UNITED STATES PATENT AND TRADEMARK OFFICE

10/582,222

Office Action Summary	Application No. 10/582,222	Applicant(s) OHMA, ATSUSHI	
	Examiner STEPHEN YANCHUK	Art Unit 1795

DETAILED ACTION

Fig. 4A

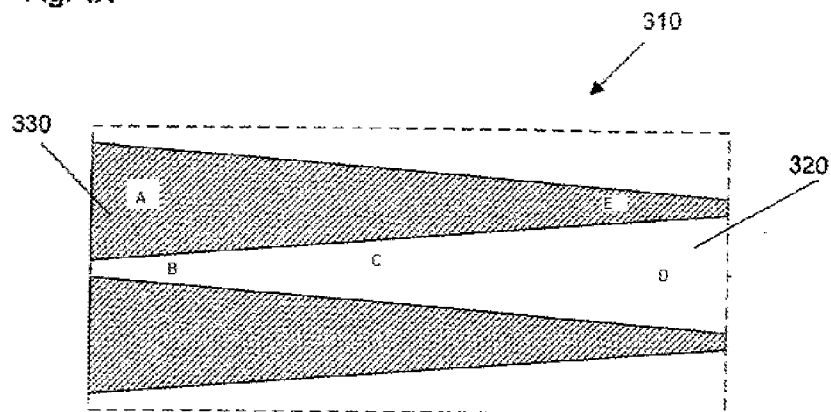
1. All outstanding objections and rejections are withdrawn in light of applicant's amendment filed on 2/03/2010
2. The text of those sections of Title 35, U.S. Code not included in this action can be found in prior office action.
3. The new grounds of rejection set forth below are necessitated by applicant's amendment filed on 2/03/2010. The following action is properly made final.
4. The 112 rejection is overcome by amendment.
5. Although the 112 rejection is overcome by amendment, the way in which the claim is written able to be broadly interpreted. The various regions shown by "A-E" are possible regions that can be used to define "1st region" and "2nd Region".

Knight teaches an electrochemical fuel cell having reactant flow passages with non-uniform design to increase reactant access to adjacent fluid distribution layer at the outlet region as compared to the inlet region [Abstract]. Knight teaches a fuel cell comprising: A membrane with electrodes on opposite sides [Paragraph 4], the plurality of cells [Description, Figure 3], at least a first region and second region wherein temperatures of the first region are higher due to change of channel structure of the flow field [Figure 4-6]. The gas diffusion is improved by the embodiments of figure 4-6, specifically figure 4 wherein the reactant flow passage widens [Paragraph 32]. It can be interpreted that each region can be higher in temperature or lower in temperature than any other region. The structure of the system goes through start up, steady state, and shut down. During Start up: section B is hotter than C hotter than D; Steady state: Section D may be hotter than C hotter than B. Sections A and E are inherently going to be lower temperature than the B-D

Claim 12: 1st region is element C and 2nd region is element B or D.

Claim 13: Knights teaches coolant flow channels that mirror the reactant flow passages [Paragraph 14, 34-39]. If region 1 is C then element B or D as the 2nd element reject this claim based on where the inlet of the coolant is, with or against the flow of the fuel.

Claim 15: 1st section is element C and 2nd section is element B wherein B is smaller in sectional area than C

Claim 16: The 1st section has not been defined structurally and is therefore open to interpretation, Sections B, C, D widen toward outlet and are lower in temperature than sections A and E as well as each other.

Claim 17: Section 1 being C or D has section B or C, respectively, where section 1 has smaller ribs wherein the ribs are the area that gas does not flow.

Claim 18: The width of the rib, around element E decreases from a 1st region of element C.
